MIL-C-22442/32
AMENDMENT 3
12 January 1990
SUPERSEDING
MIL-C-22442/32
AMENDMENT 2
2 September 1988

CABLE ASSEMBLY, RADIO FREQUENCY
(AIRCRAFT AUDIO), ASSOCIATED PARTS

This amendment forms a part of military specification MIL-C-22442/32 dated 14 November 1984 and is approved for use by all Departments and Agencies of the Department of Defense.

FIGURE 1. Clamp-electrical plug connector.

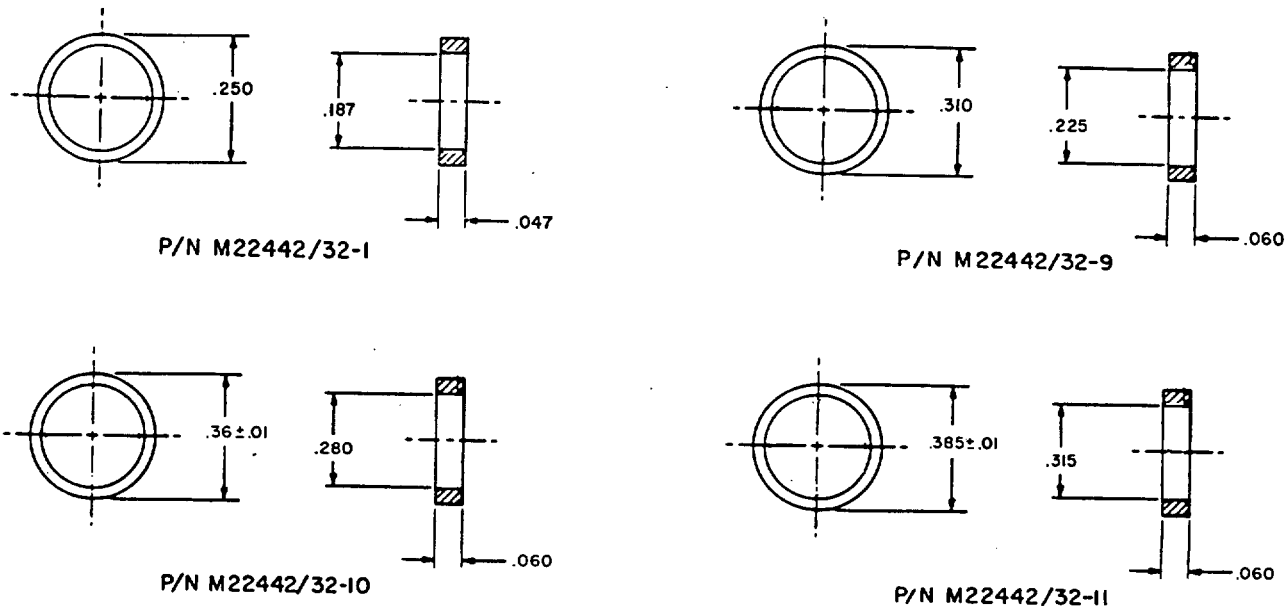
Delete Figure 1. Add new Figure 1.

FIGURE 8. Grommet communications cord P/N M22442/32-8.

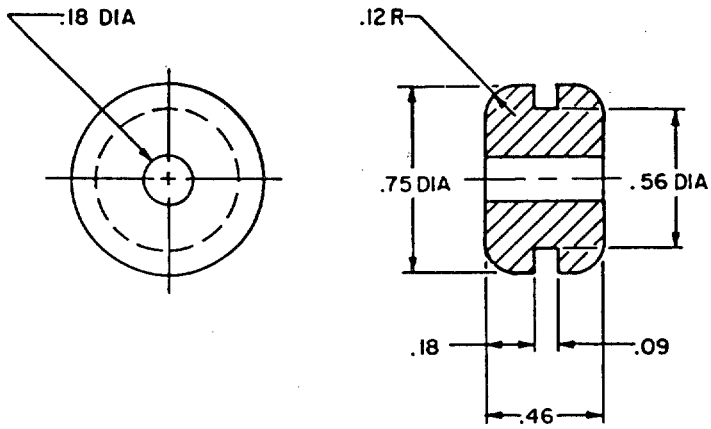
Add new page 8.

1. The grommet shall be rubber in accordance with MIL-R-2765 rubber sheet, strip, extruded and molded shapes, synthetic, oil resistant color black.

FIGURE 9. Contact-electrical cord assembly beveled P/N M22442/32-12.

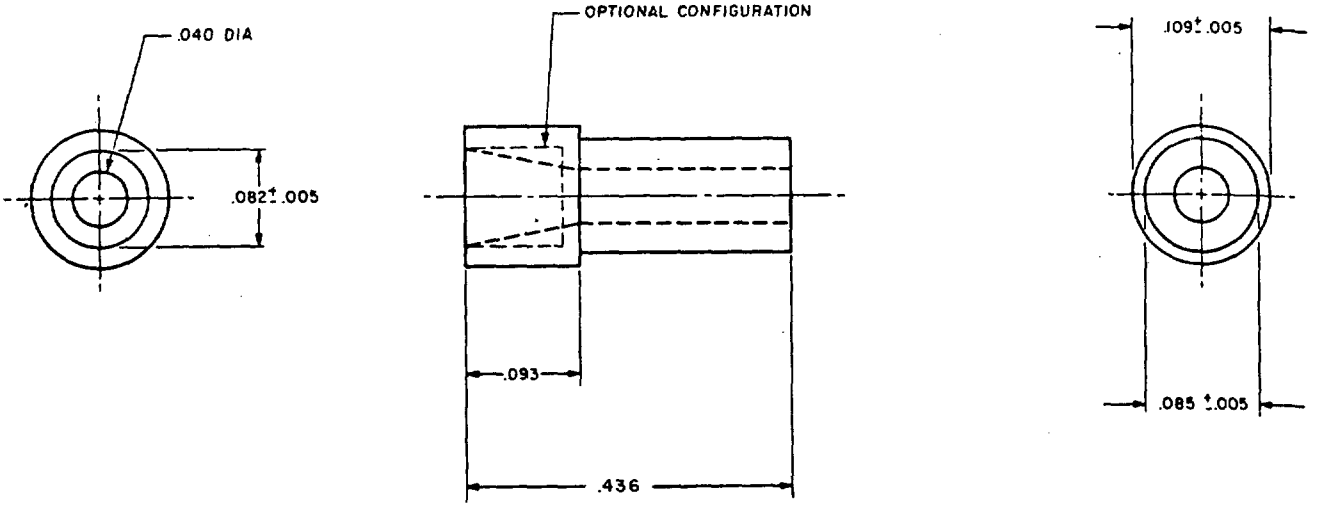
*Add new page 9.

1. The contact shall be brass in accordance with QQ-B-626, Alloy 360, 1/2 hard.
2. The contact shall be finished 32√ in accordance with ANSI B46.1.62.
3. The contact shall be silver plated in accordance with QQ-S-365 Grade B .0003 thick solderable. Optional plating may be M-262 cadmium plate in accordance with MIL-F-14072 or nickel plate.
